ARDEN SENIOR LIVING CENTER

SITE DEVELOPMENT PLAN

ARDEN SENIOR LIVING CENTER
SITE DEVELOPMENT PLAN
ROLESVILLE, NORTH CAROLINA

OPEN SPACE
PLAN

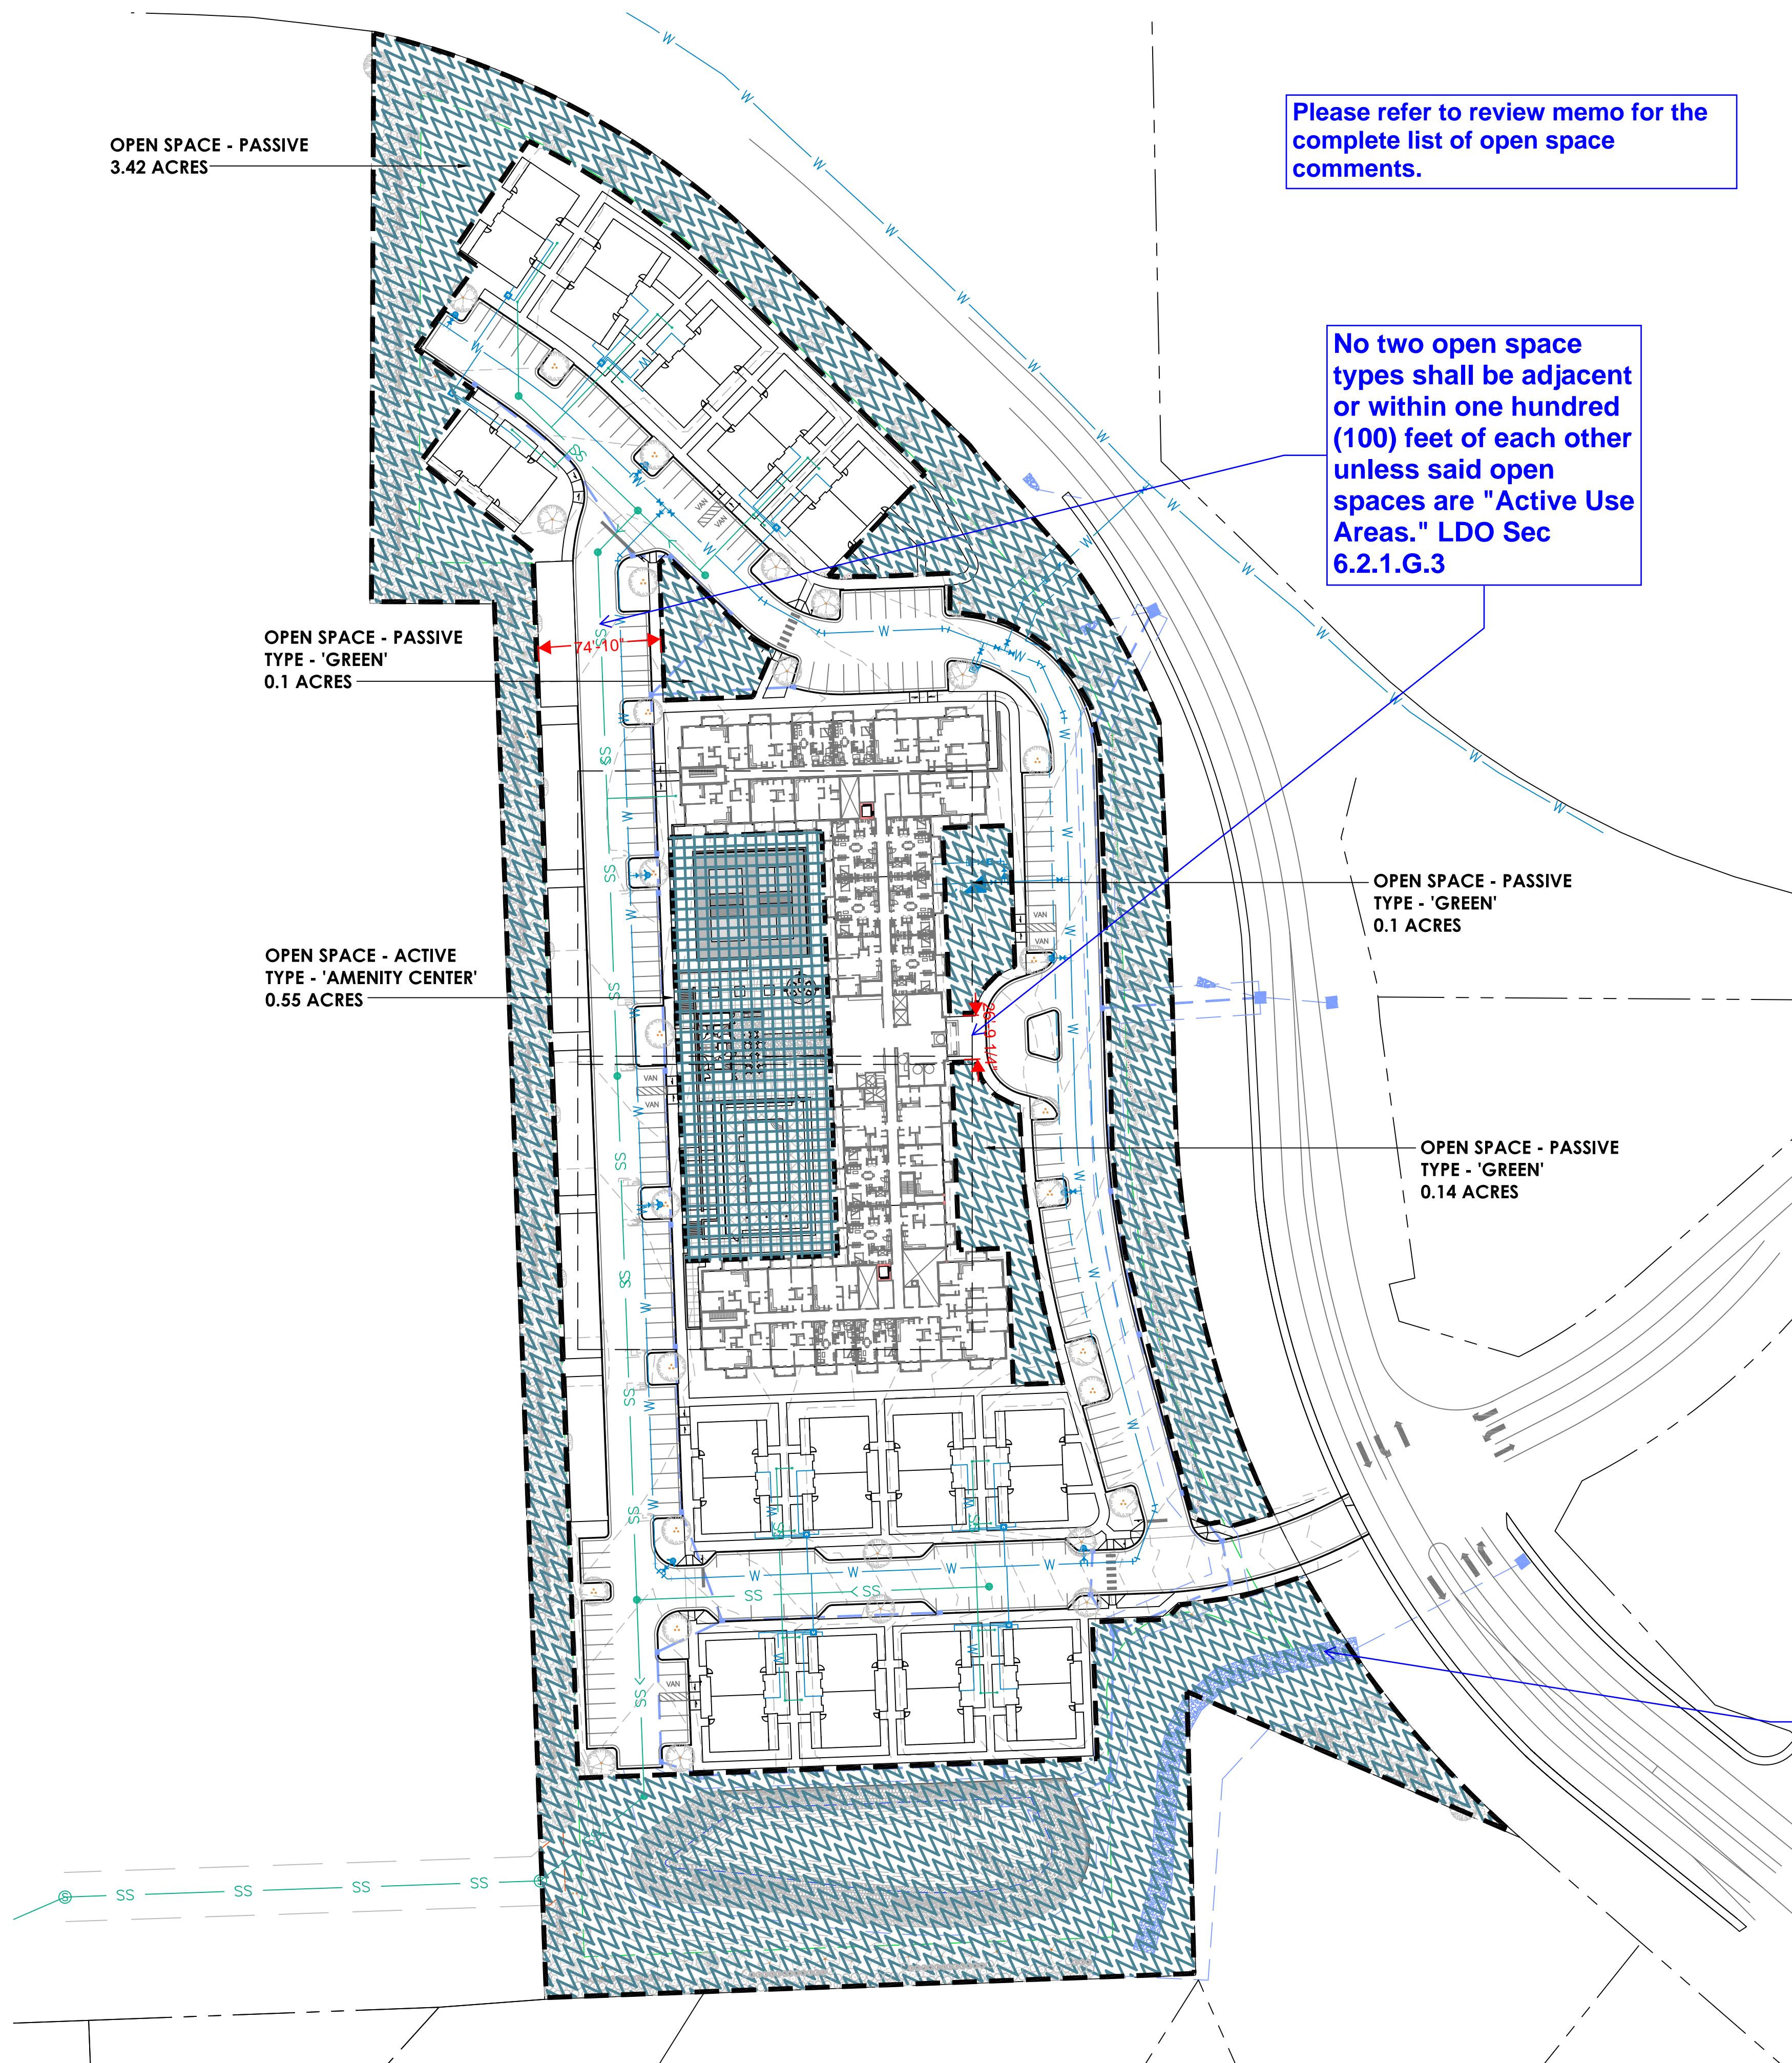
No two open space types shall be adjacent or within one hundred (100) feet of each other unless said open spaces are "Active Use Areas." LDO Sec 6.2.1.G.3

What does this blue path symbolize?

OVERALL PLANTING
KEY PLAN

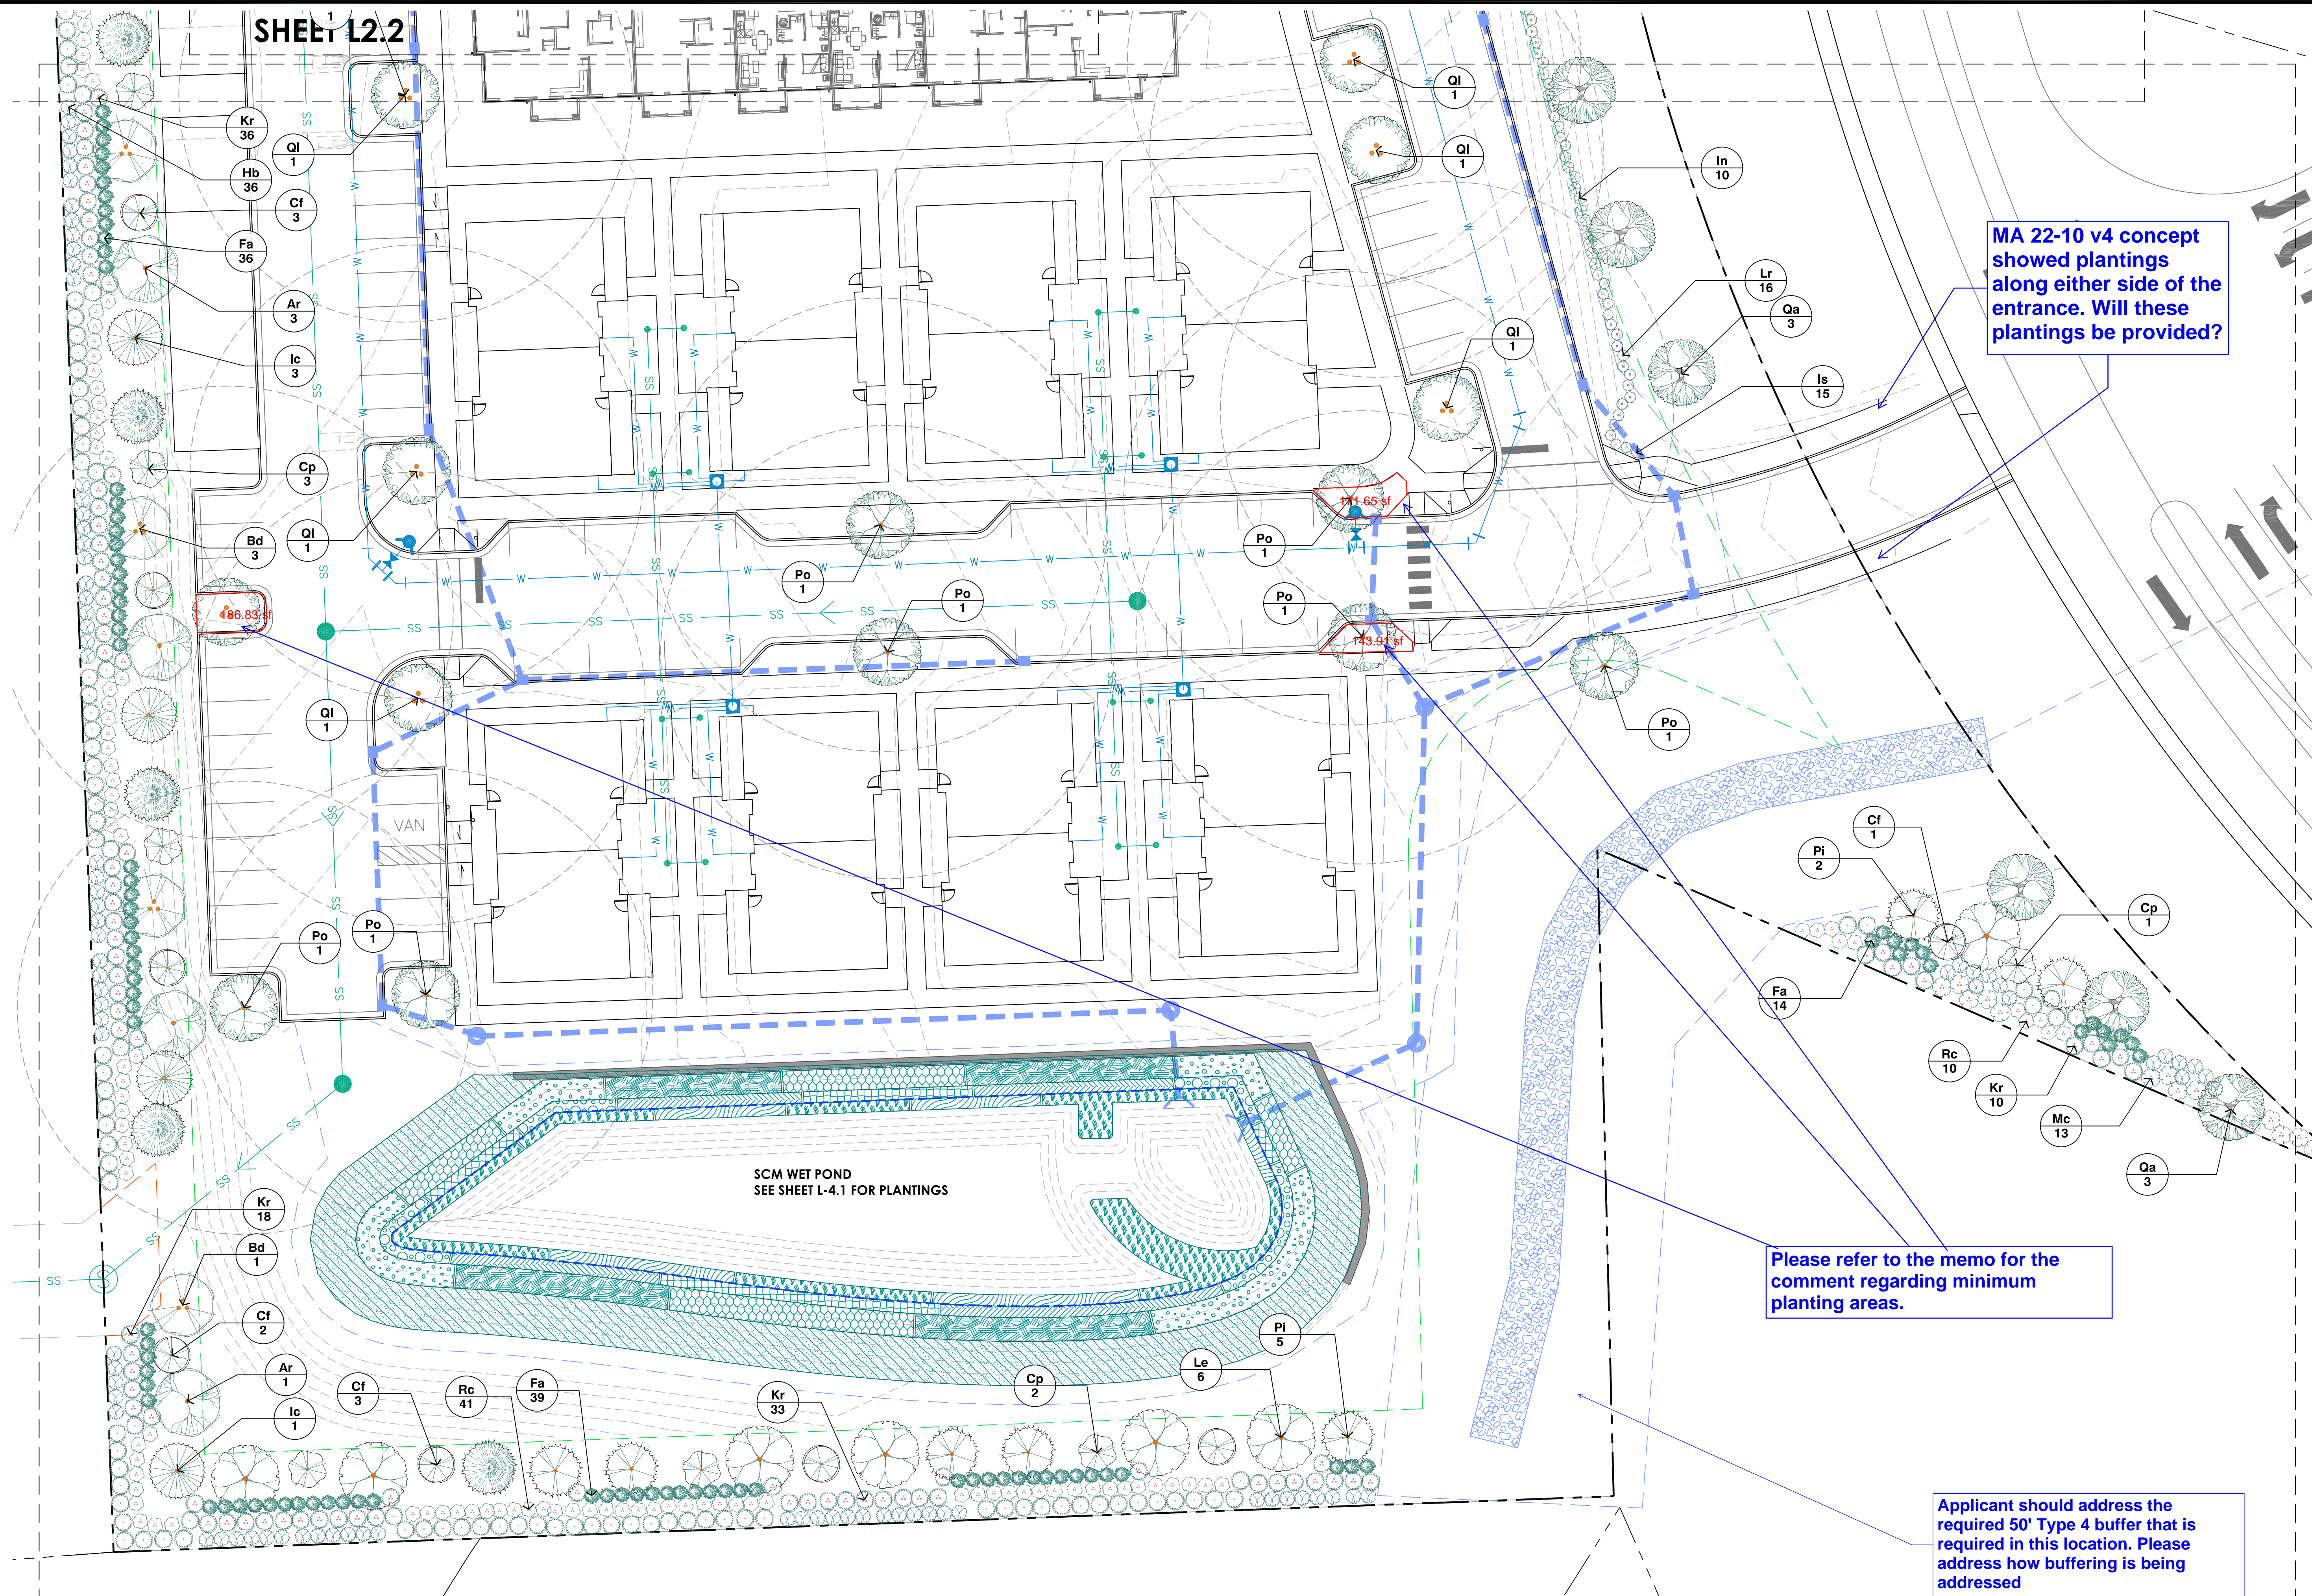
Please provide an overall legend for the various colors and symbols that are being shown on the plan sheet.

Please update the planting schedule to include a column that clarifies which requirement the planting is fulfilling (i.e. streetscape buffer, perimeter buffer, screening, etc.)

MA 22-10 v4 concept showed plantings along either side of the entrance. Will these plantings be provided?

Please refer to the memo for the comment regarding minimum planting areas.

SHEET L2.1

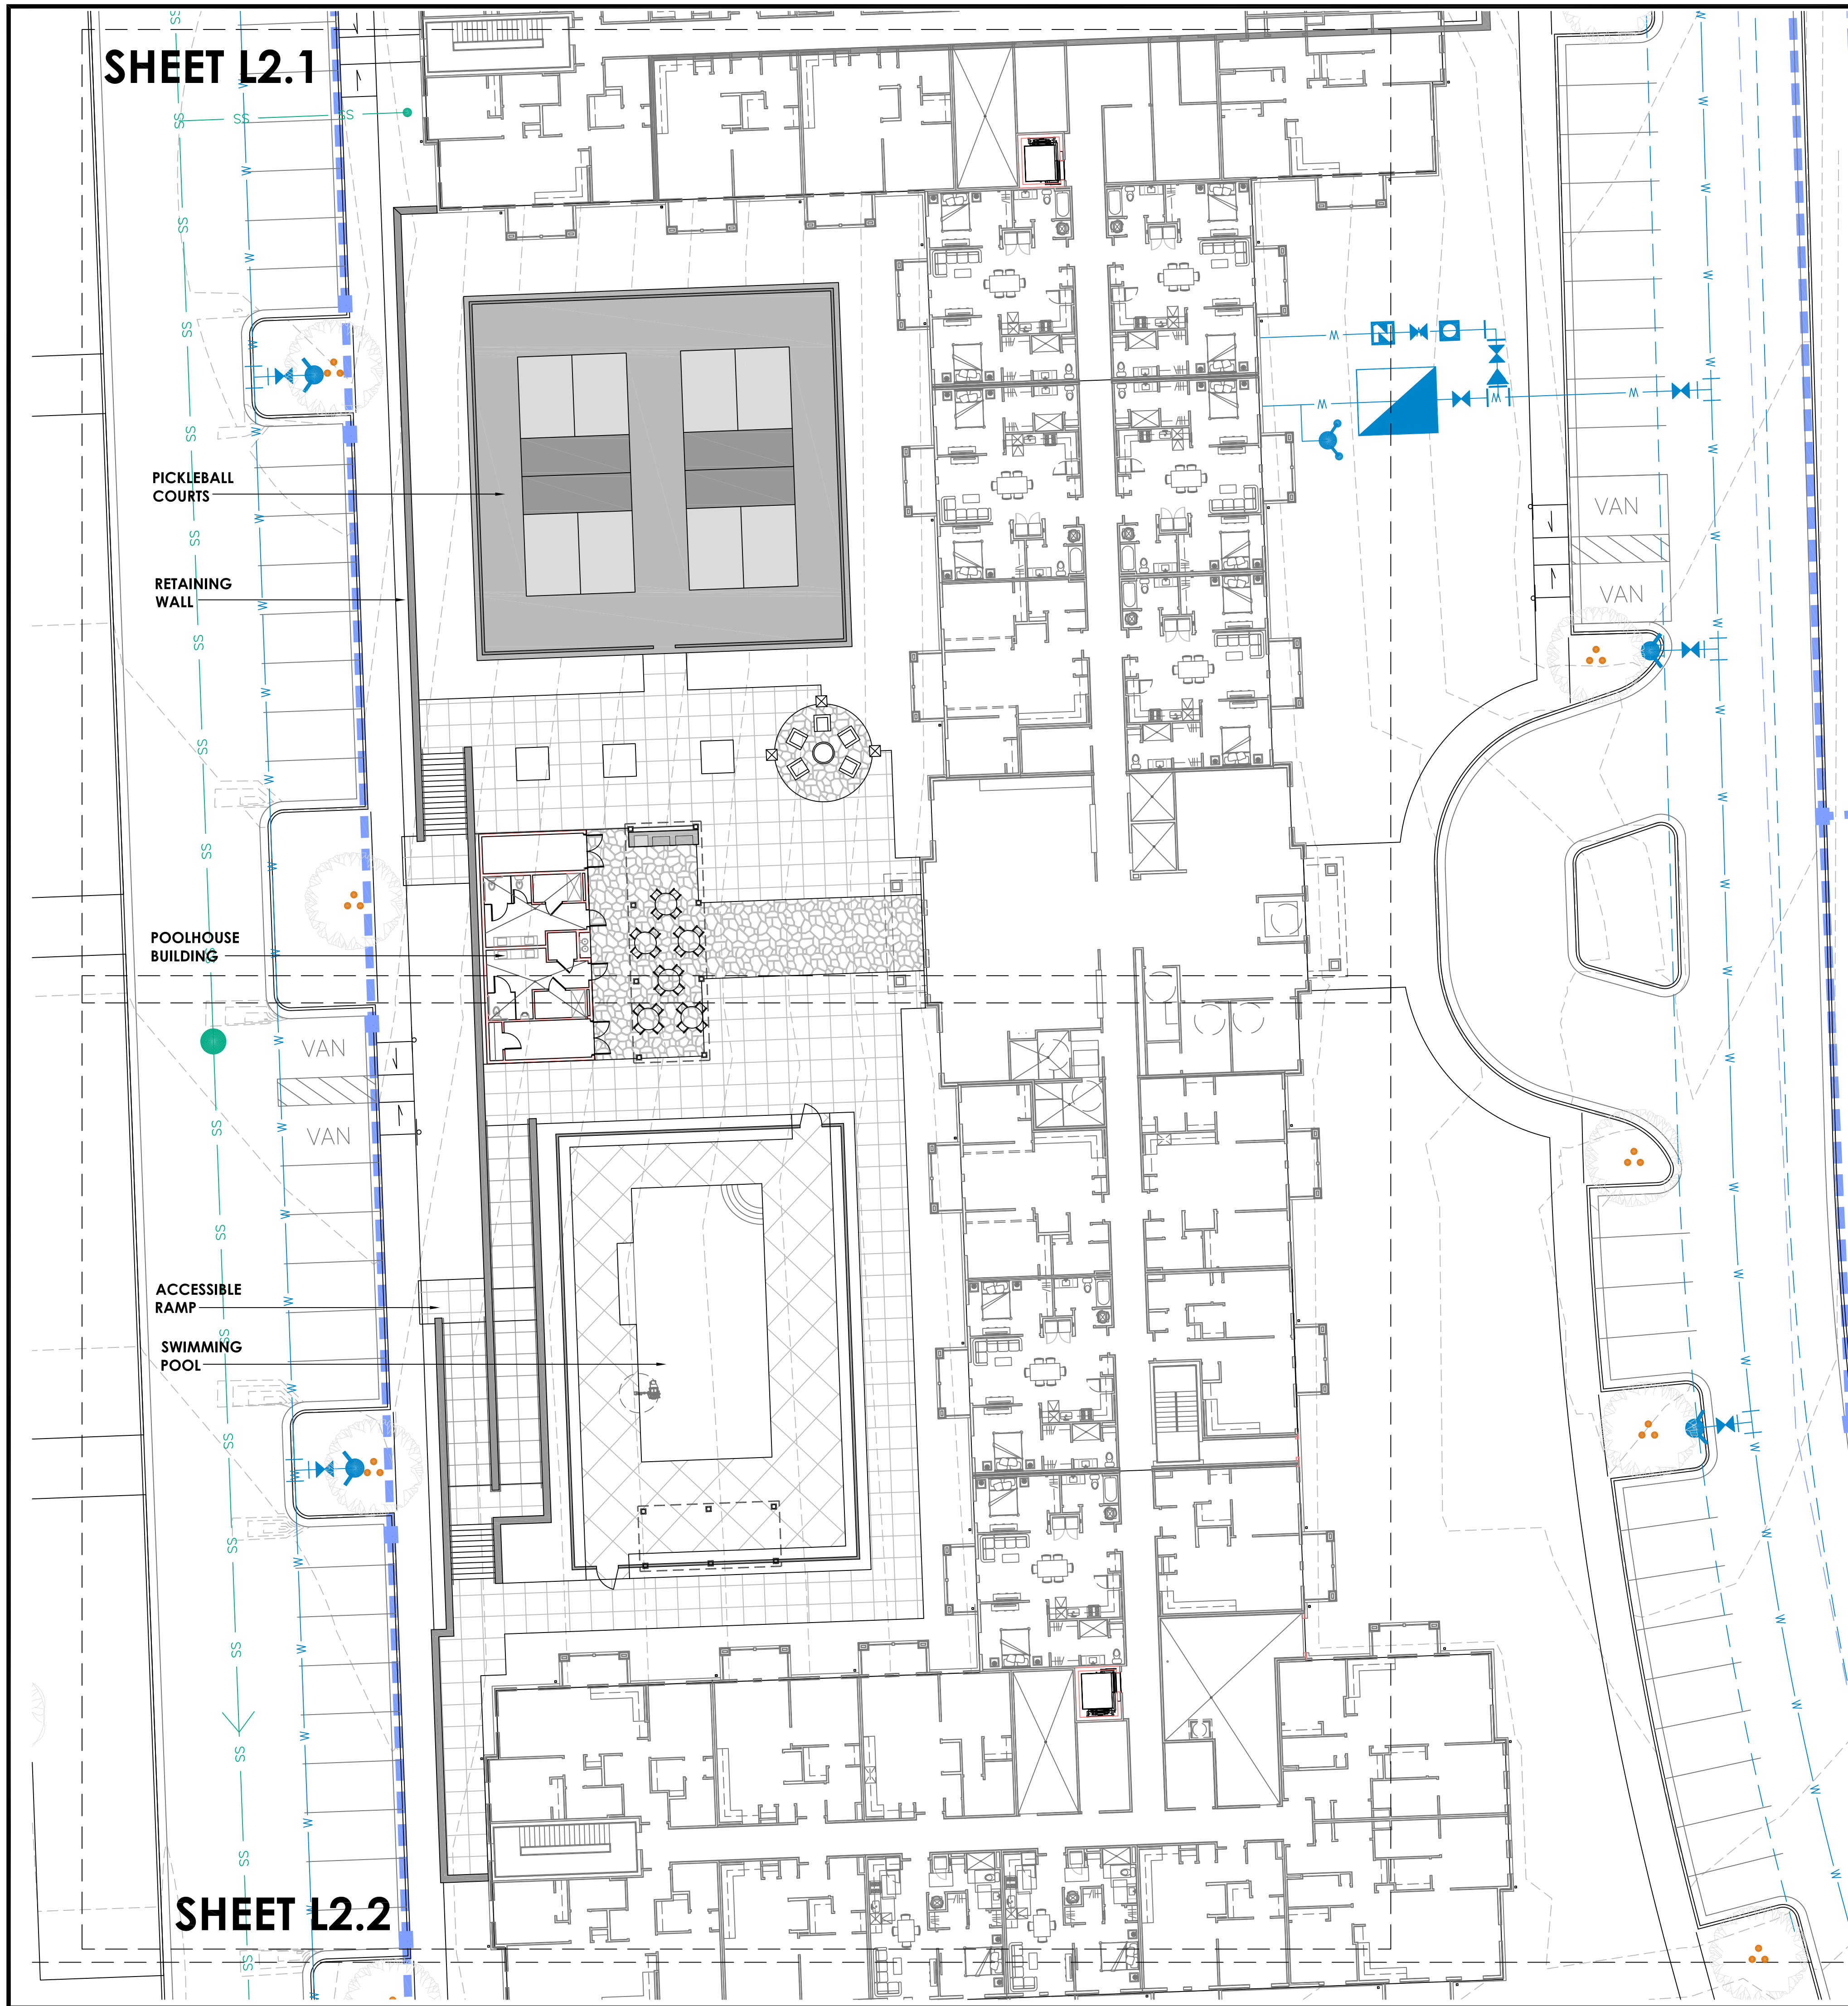
Label all trash receptacles and public seating areas on the hardscape plan sheets.
